**PROJECT: BR-0016-02(038)/107570301 - Attala  
BR-0016-02(038)/107570302 - Carroll  
BR-0016-02(038)/107570303 - Leflore**

SECTION 904 -NOTICE TO BIDDERS NO. 254

## SUPPLEMENT TO SPECIAL PROVISION NO. 907-618-3

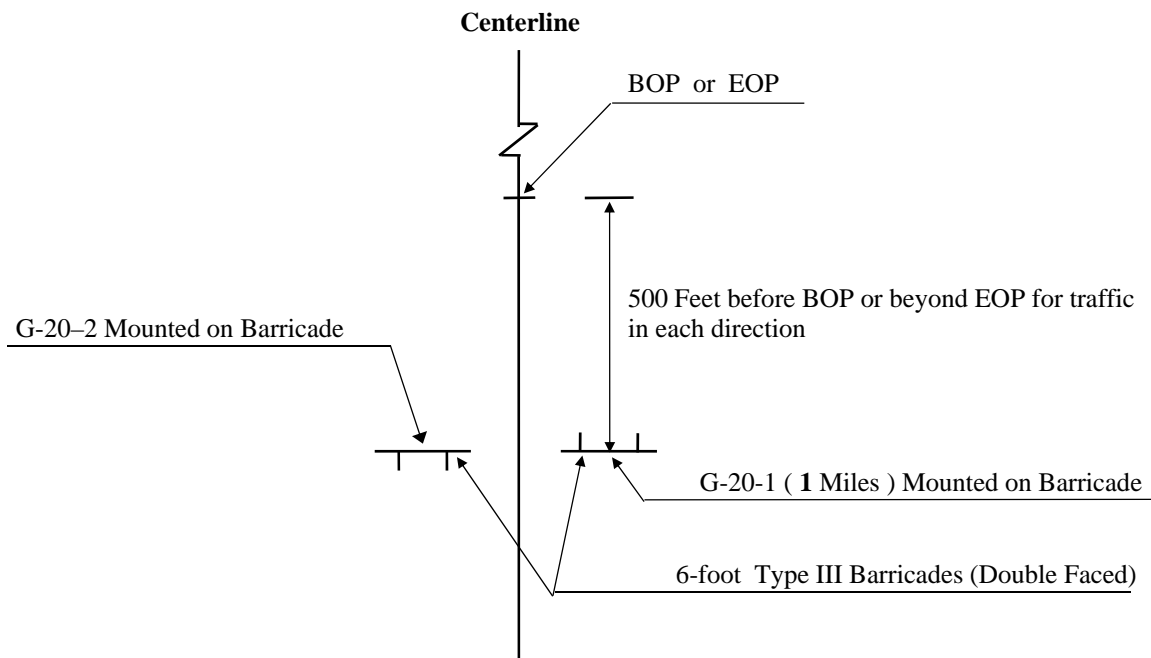
After the first paragraph of Subsection 907-618.01.2 on page 1, add the following.

Additional signs will be required as follows at all bridge sites.

### ADDITIONAL TRAFFIC CONTROL SIGNS REQUIRED:

- 0 - W20-1 "AHEAD" signs required. One (1) W20-1 "AHEAD" sign is required at each local road or street entering the project.
- 0 - R4-1 "DO NOT PASS" signs required.
- 0 - R4-2 "PASS WITH CARE" signs required.
- 0 - W14-3 "NO PASSING ZONE" signs required.

R4-1 "DO NOT PASS", R4-2 "PASS WITH CARE", and W14-3 "NO PASSING ZONE" signs are required in accordance with Subsection 618.03.3, this drawing, and as specified in the Manual on Uniform Traffic Control Devices. If no passing zones are 1,000 feet or more, additional "DO NOT PASS" signs shall be installed.

All Construction signing is included in the bid for Pay Item 618-A, Maintenance of Traffic. Fluorescent orange sheeting shall be used on all construction and traffic control signs except for R4-1 and R4-2 signs which shall be black legend and border on white background.
